Addendum #1 - Bid Package #6929-07

Project Name: Lincoln Public Schools District Office
5901 'O' Street
Lincoln, NE
Project No.: 11065
Issued: August 3, 2012

08/03/2012
 SHEET
M101
 ATTACHMENT NO.
M2
 TSM

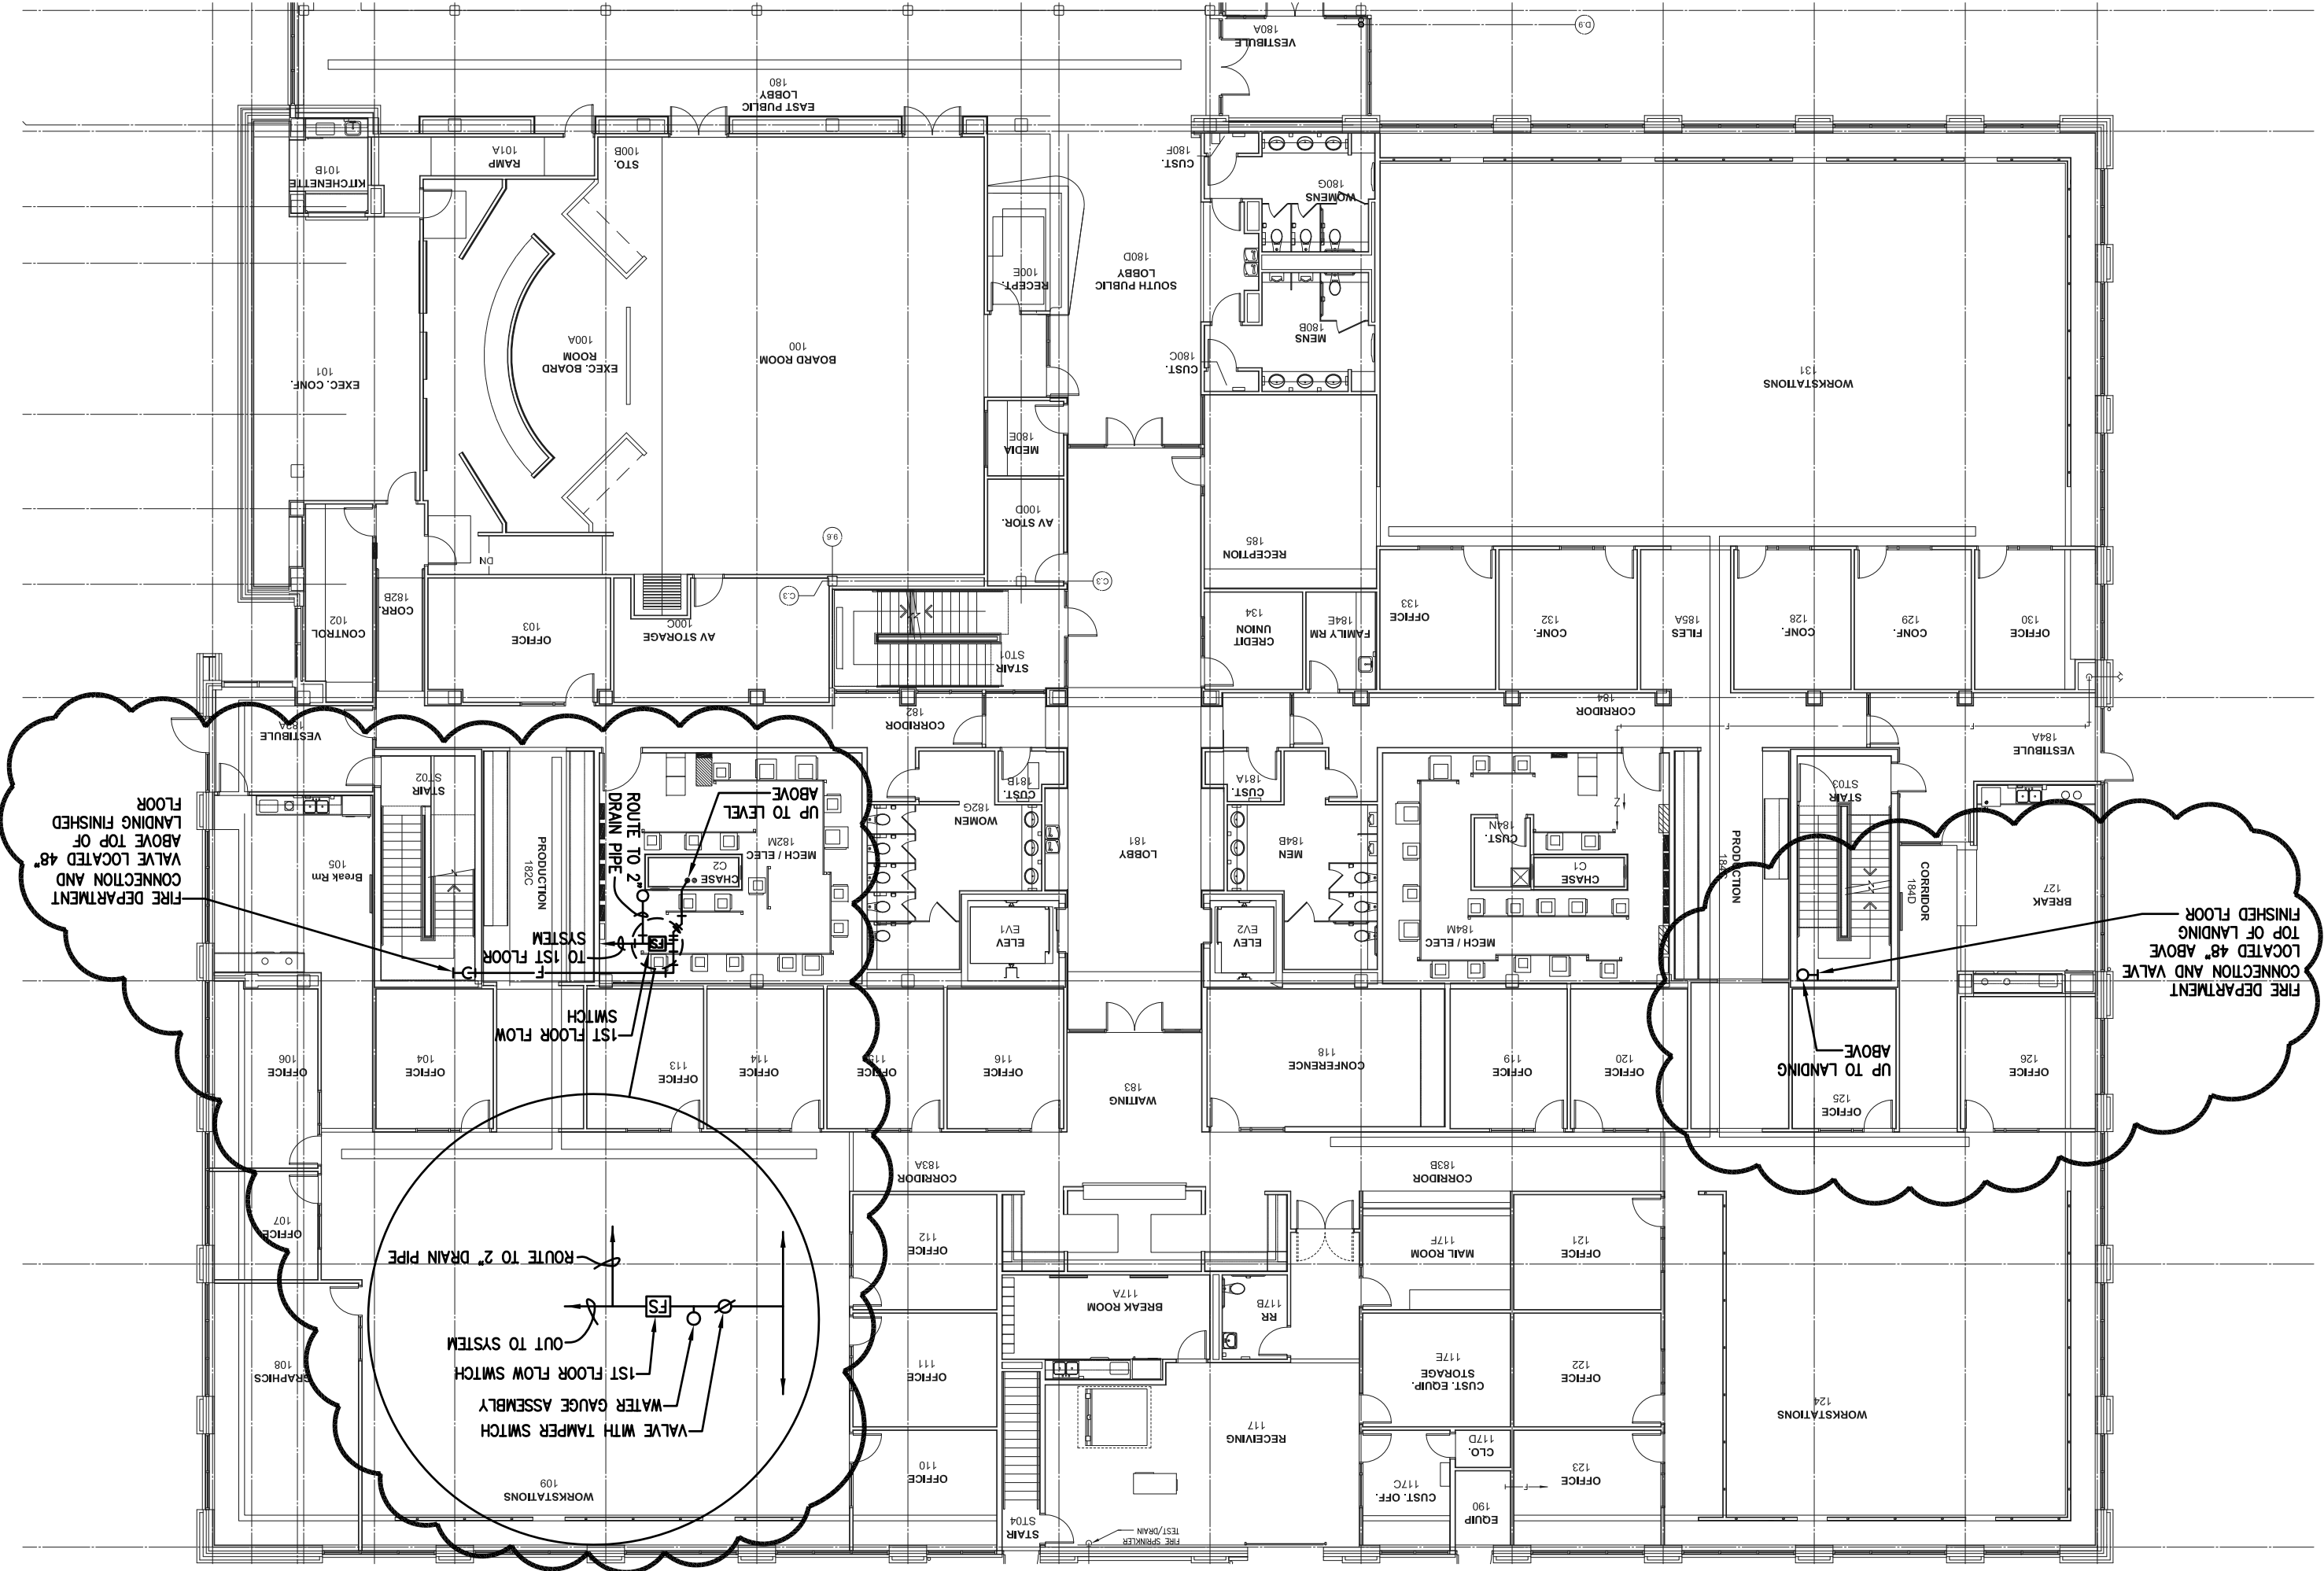
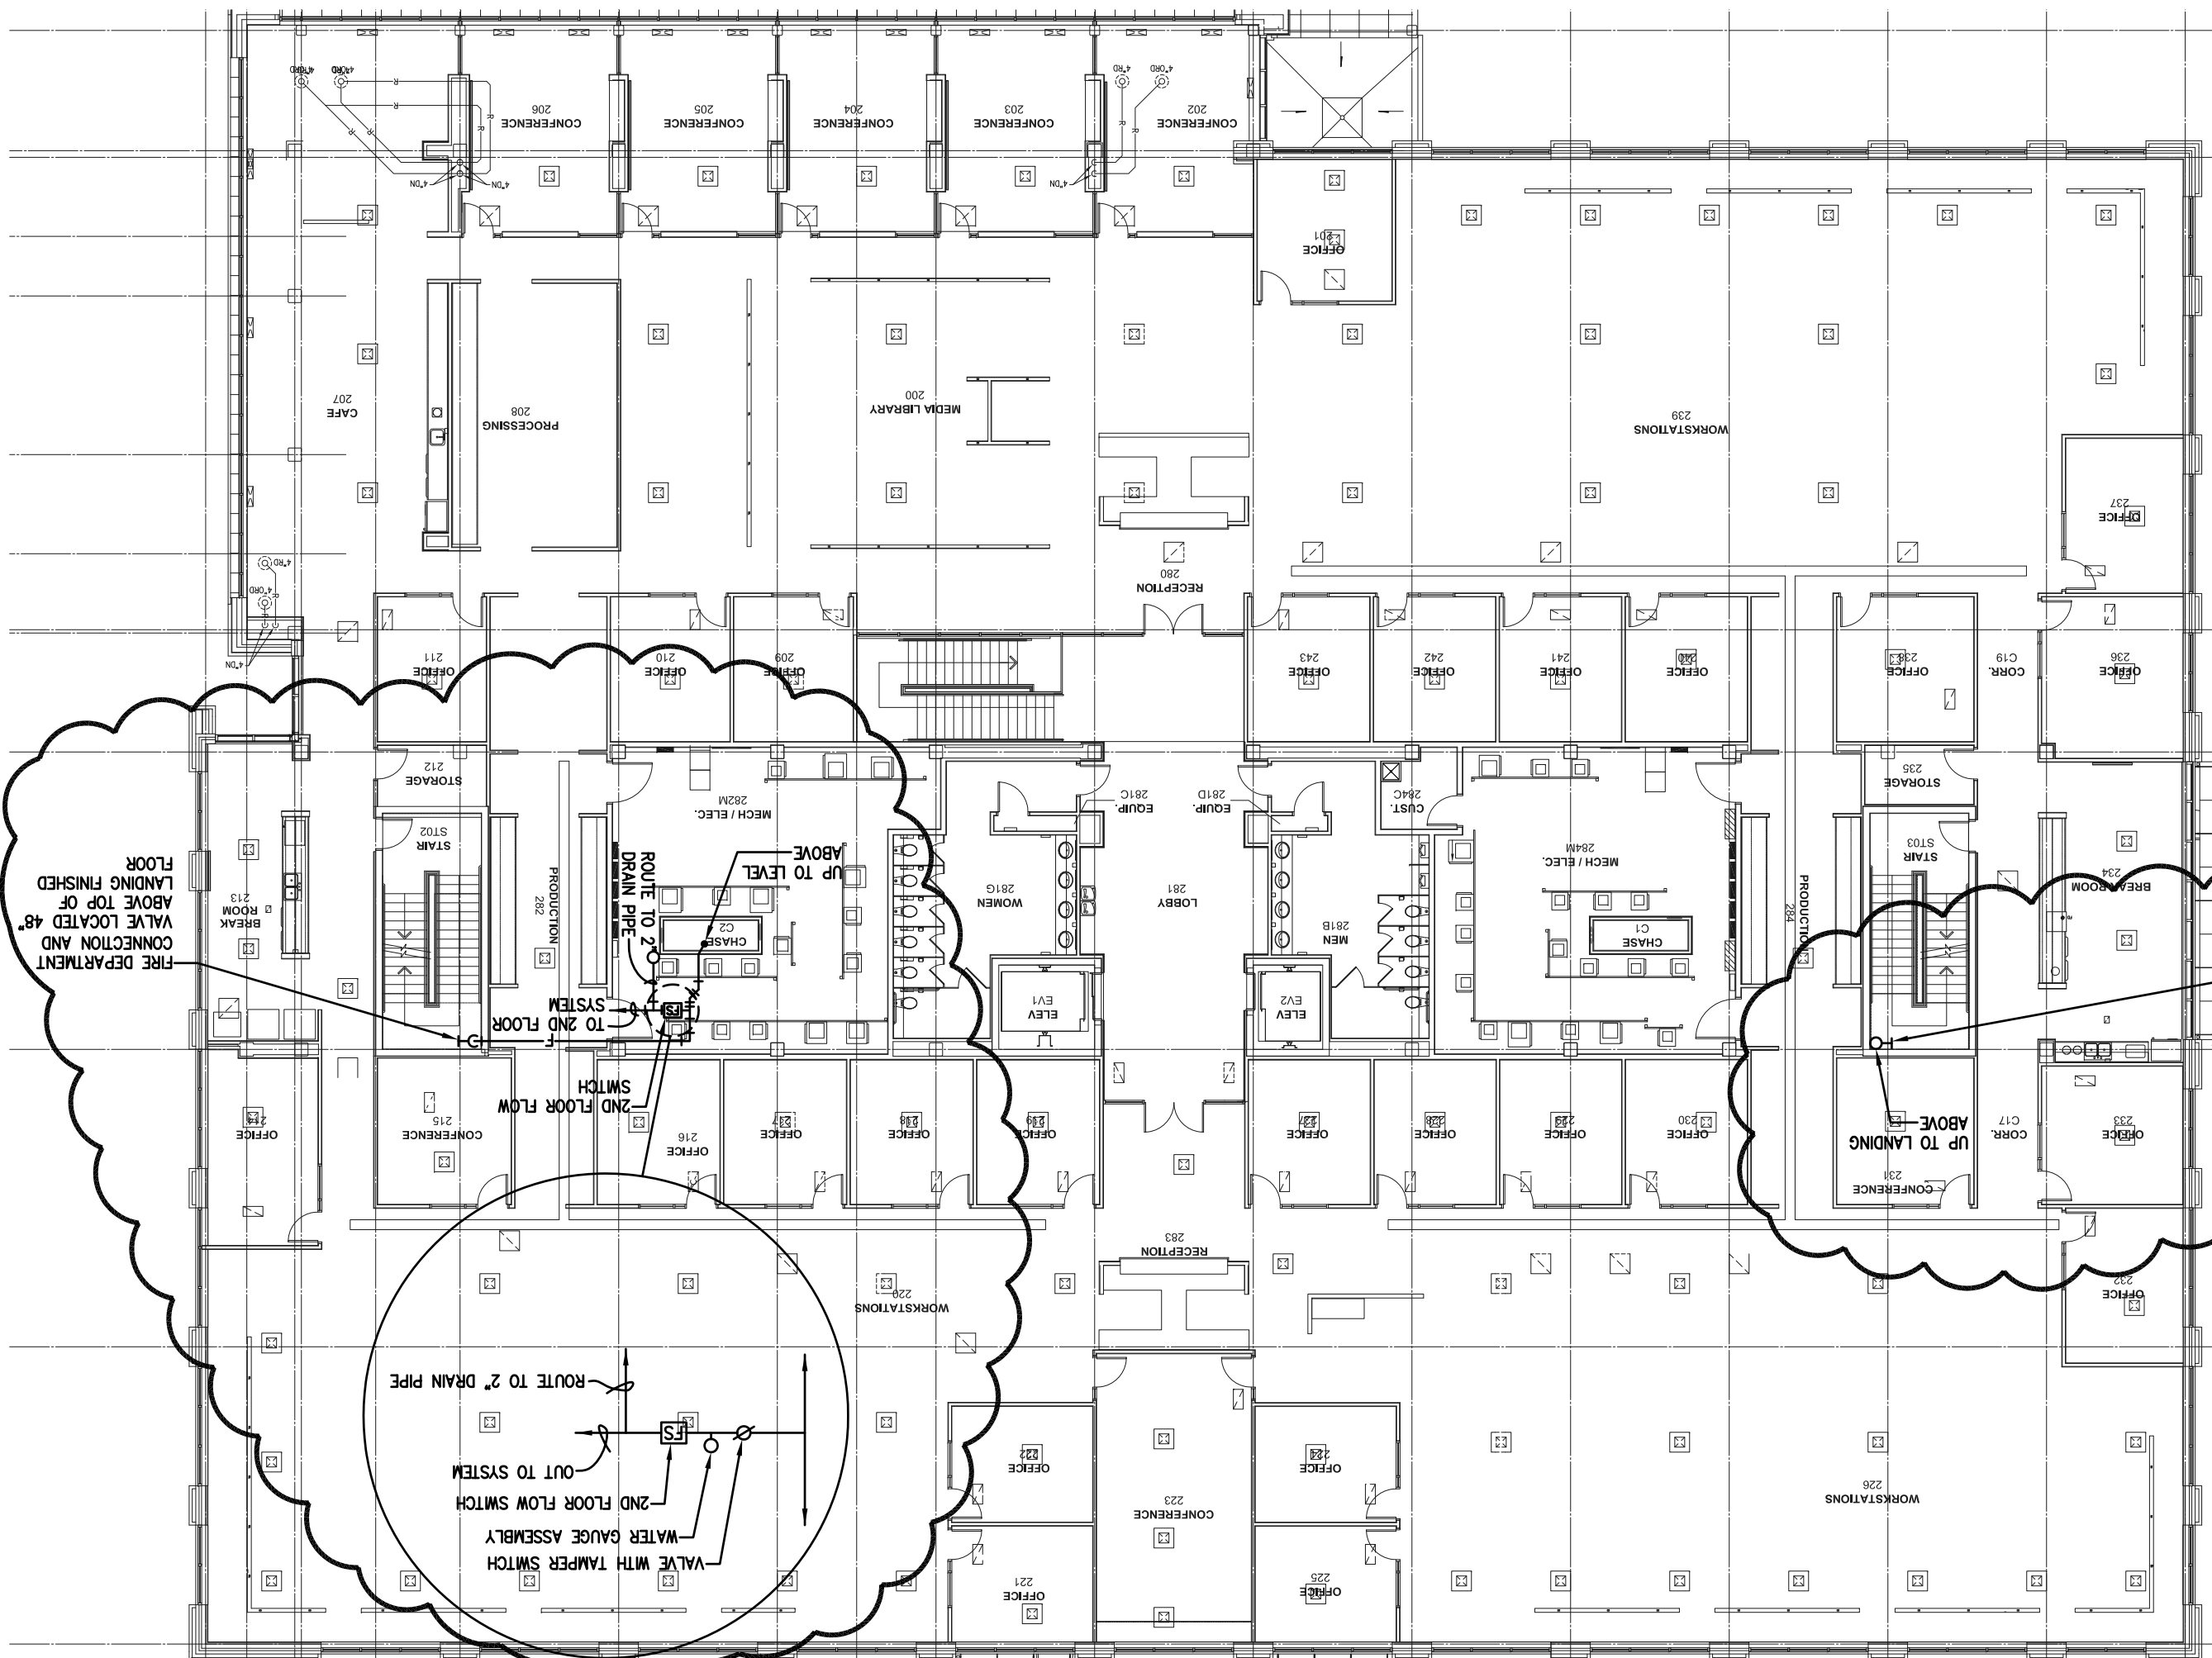
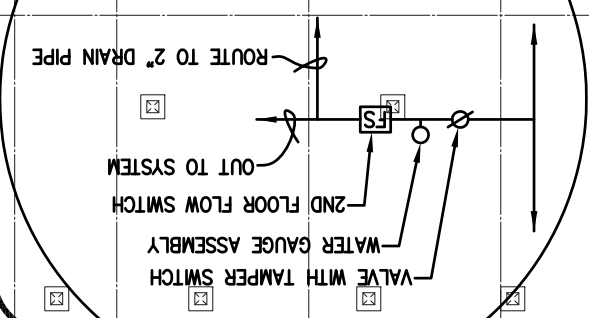
ADD 1-16. Refer to Sheet M101 – First Floor Plan – Mechanical

- A. Refer to **attachment M2** for revised fire sprinkler piping.
 - i. Provide fire sprinkler standpipe in Stair ST03 and ST02 with fire department connect on intermediate levels.
 - ii. Provide 1st floor flow switch in Mech/Elec 182M. Route test/drain to exterior.
